PERMIT
SEWAGE DISPOSAL SYSTEM
HOWARD COUNTY HEALTH DEPARTMENT
BUREAU OF ENVIRONMENTAL HEALTH
410-313-2640

SUBDIVISION Woodcamp Farm LOT NUMBER 11 ADDRESS 17593 Woodcamp Road

Approved Septic System Plan
Howard County Health Department

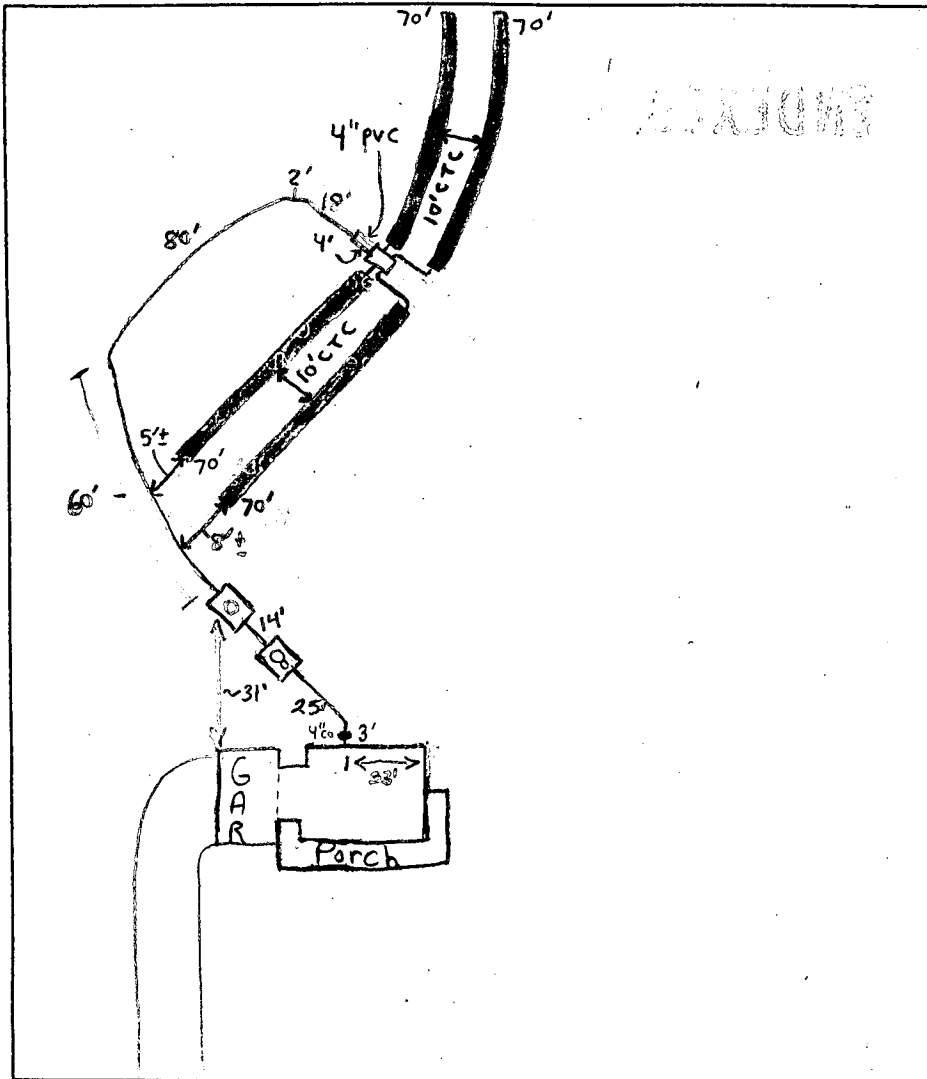
LOCATION: Begin trenches 160 feet off the rear lot line and 80 feet off the right lot line as seen when facing the lot from Woodcamp Road. Run trenches on contour in both directions. 8/10/2000

Keep trenches 7' edge to edge (10' center to center) to conserve future septic repair area

PRE-CONSTRUCTION INSPECTION: 3/27/01 Tanks set. Installer wants to put in 4-70' trenches. O.K. (BB)

INSPECTION COMMENTS: 3/28/01- SYSTEM INSTALLED VERY WELL, OK TO COVER ALL WORK, PUMP AND ALARM TEST STILL NEEDED FOR FINAL APPROVAL

(SRW) 6/1/01 PUMP/ALARM OK (MR)

SEPTIC DESIGN DATA

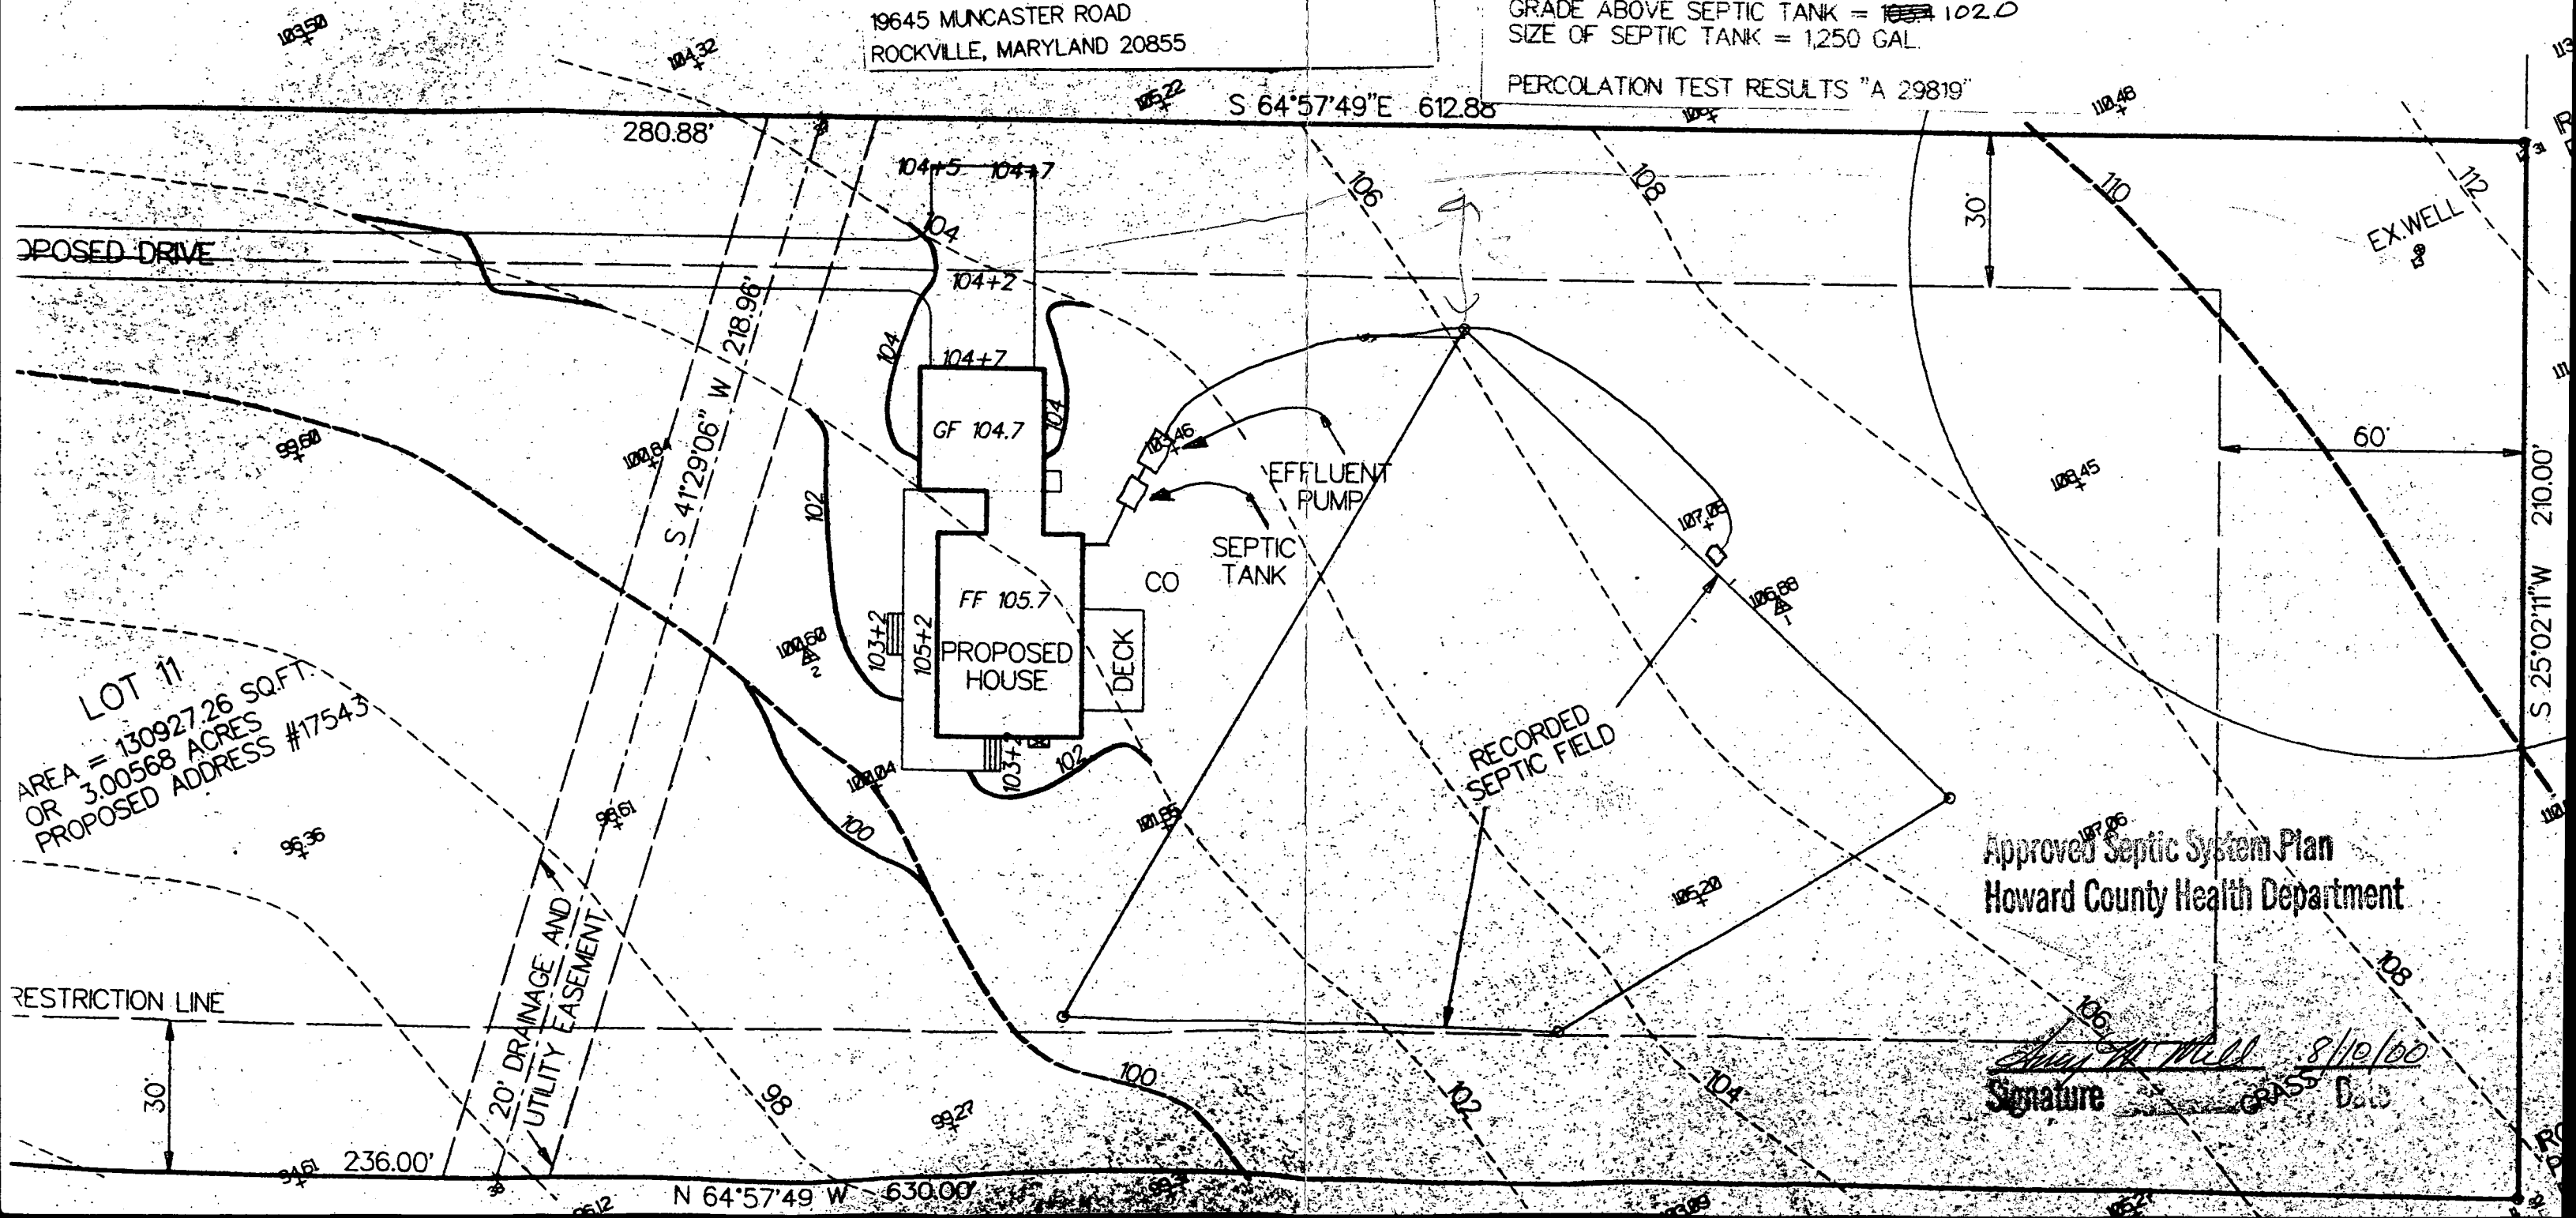
INVERT BEGIN FIELD = 102.9
INVERT AT GRAVITY CO = ~~102.9~~
INVERT INTO PUMP CHAMBER = ~~99.5~~ 99.0
INVERT OUT OF SEPTIC TANK = ~~99.3~~ 99.3
INVERT IN TO SEPTIC TANK = ~~99.7~~ 99.5
INVERT OUT OF HOUSE = 99.7
LENGTH OF INITIAL SYSTEM = 280' Provided
USE FOUR (4) TRENCHES OF LENGTH 70'
